DEPARTMENT OF THE NAVY

Crane Division, Naval Surface Warfare Center submits the Final Corrective Measures Proposal (CMP) for the Old Rifle Range and Old Pistol Range (ORR/OPR), Solid Waste Management Unit 07 as enclosure (1). The responses to the U. S. EPA comments are presented as enclosure (2). The permit required Certification Statement is provided as enclosure (3).

**RESPONSES TO US EPA COMMENTS
FROM PETER RAMANAUSKAS (MAY 23, 2006) VIA E-MAIL
ON THE CORRECTIVE MEASURES PROPOSAL (CMP)
FOR SWMU 7 – OLD RIFLE RANGE/OLD PISTOL RANGE
NSWC CRANE
CRANE, INDIANA**

REVISED APPENDIX B

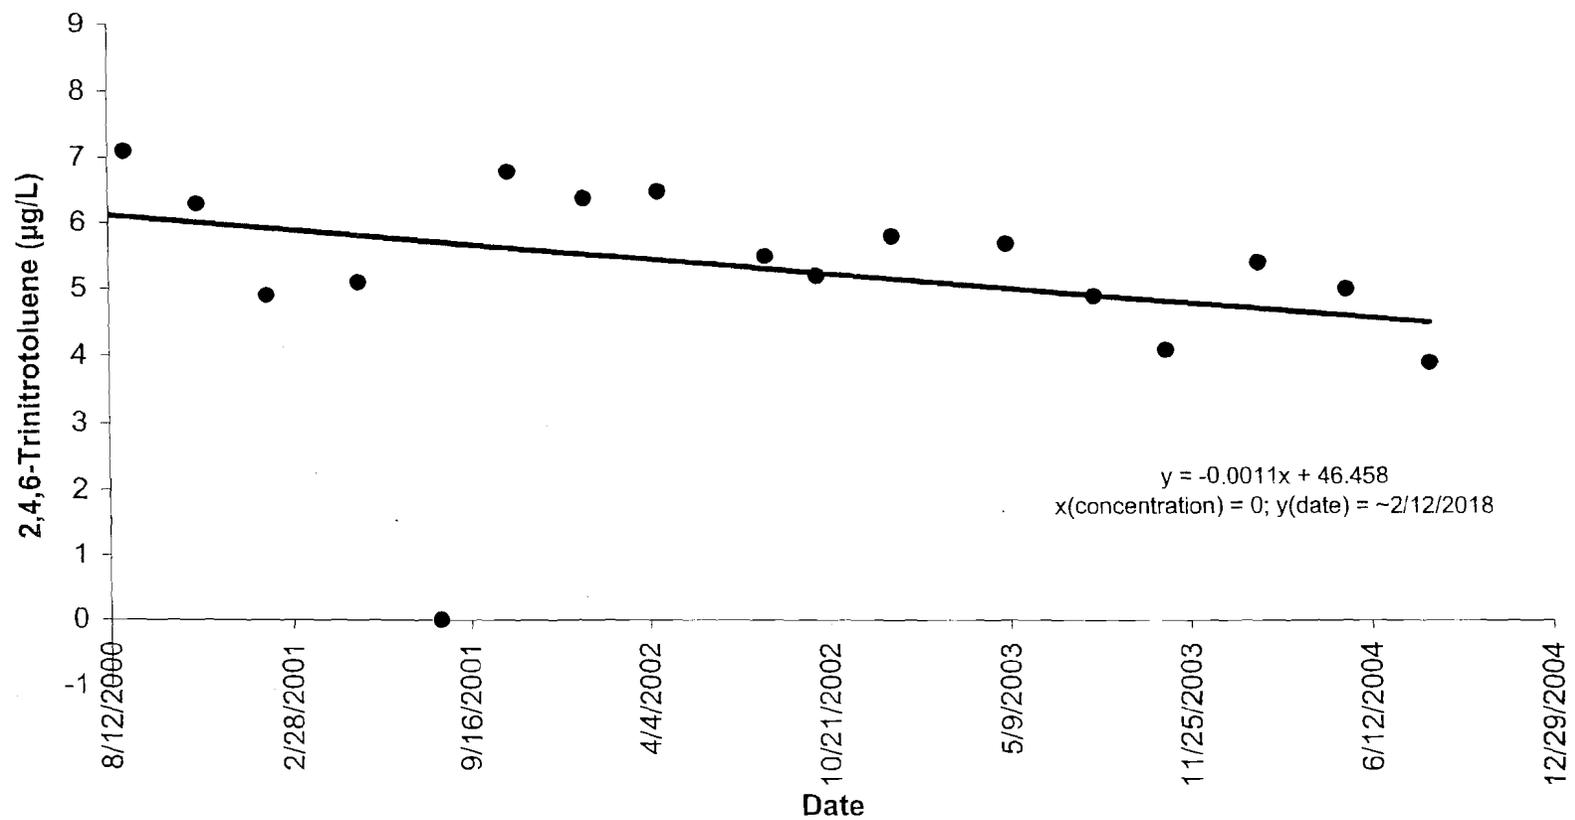
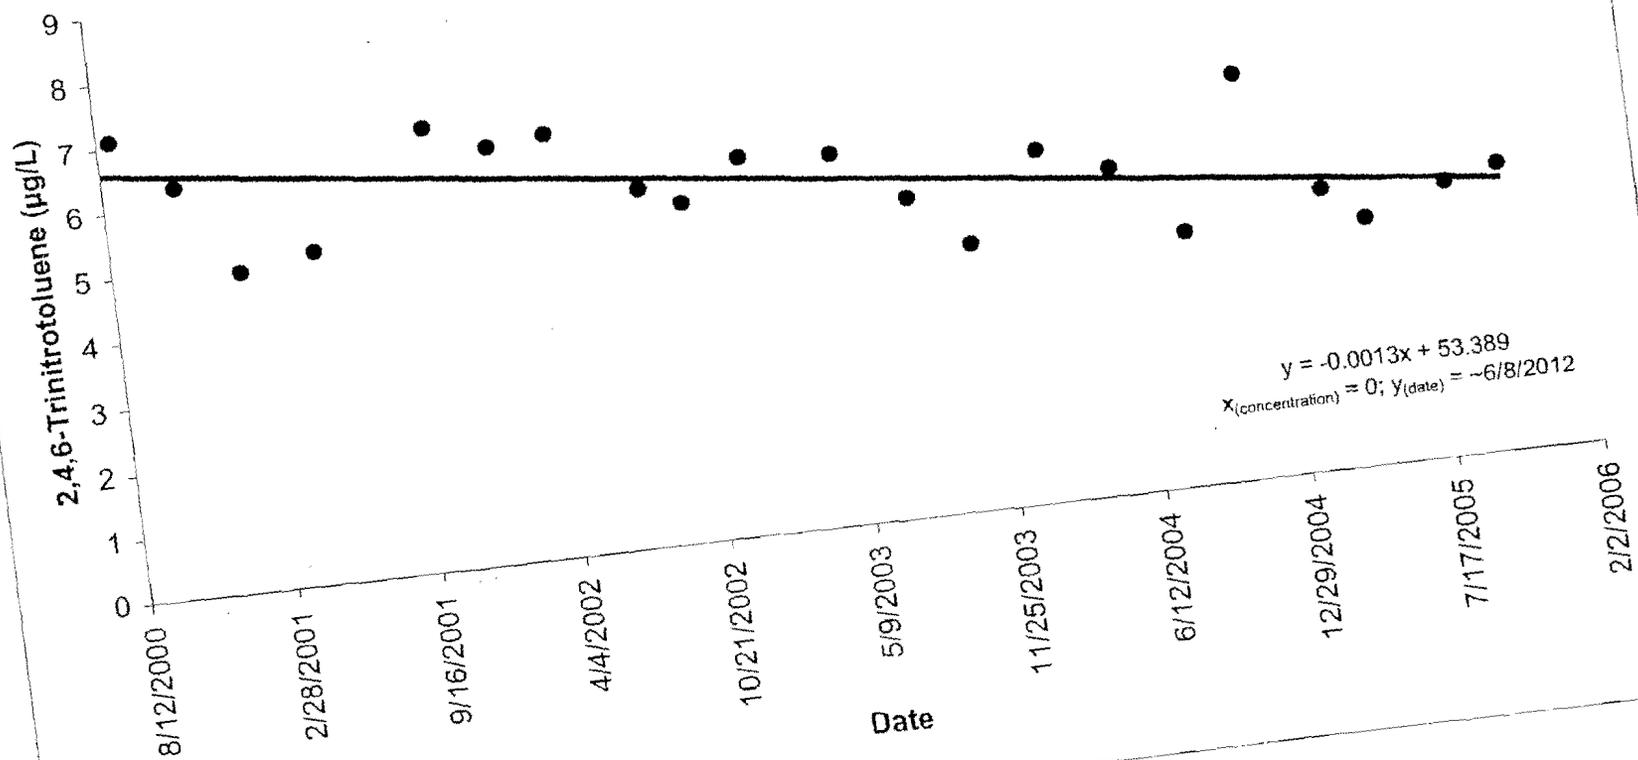
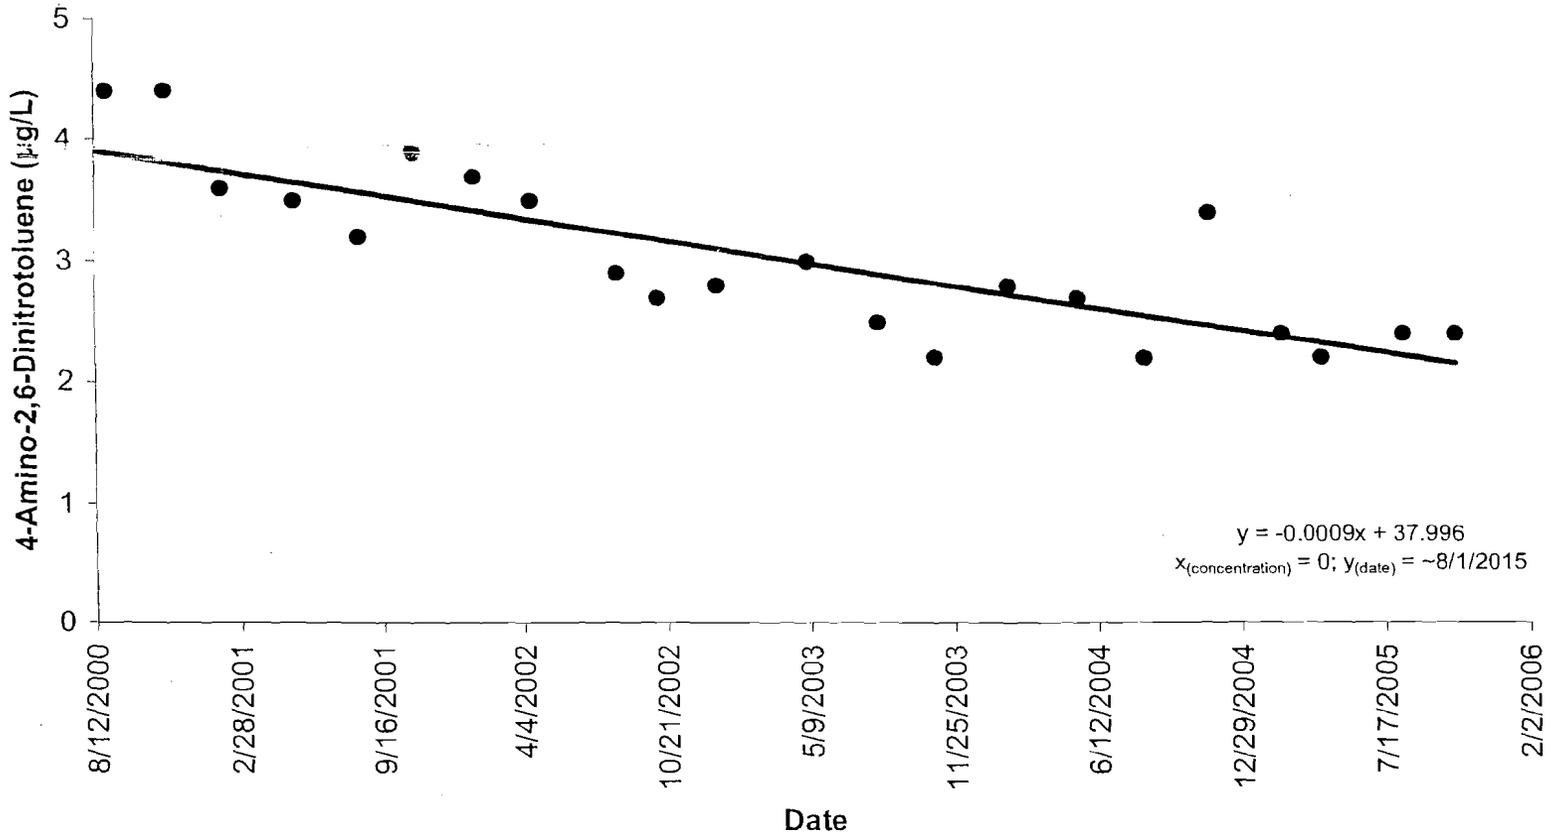
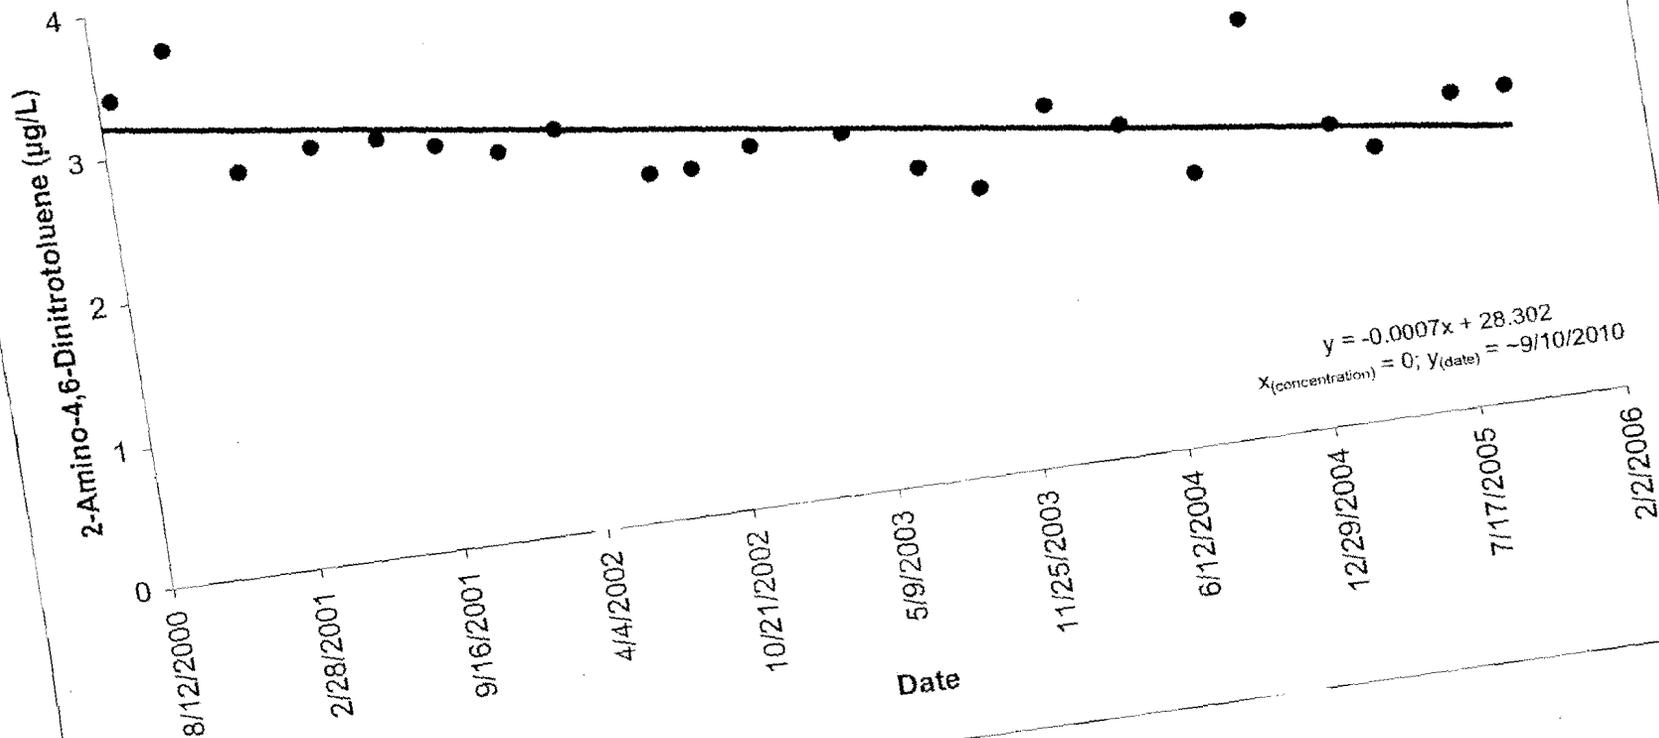
Comment EPA-3: Referring to Section 2.1.2 (Explosives), update the trend plots in Appendix B with 2005 data.

Comment EPA-7: Referring to Section 4.1.2.2, can existing quarterly monitoring be used to roughly predict attainment of TNT MCS?

Response to comment EPA-3: Appendix B temporal plots and input data have been updated to include the data from the 2005 Groundwater Monitoring Program and are provided as Attachment 1 to this response document.

Response to Comment EPA-7: Appendix B has been updated for the 2005 quarterly monitoring data. Based upon monitoring well 06C15 and the temporal plots presented in Appendix B, it is anticipated that concentration of TNT will achieve a non-detection concentration in 2018.
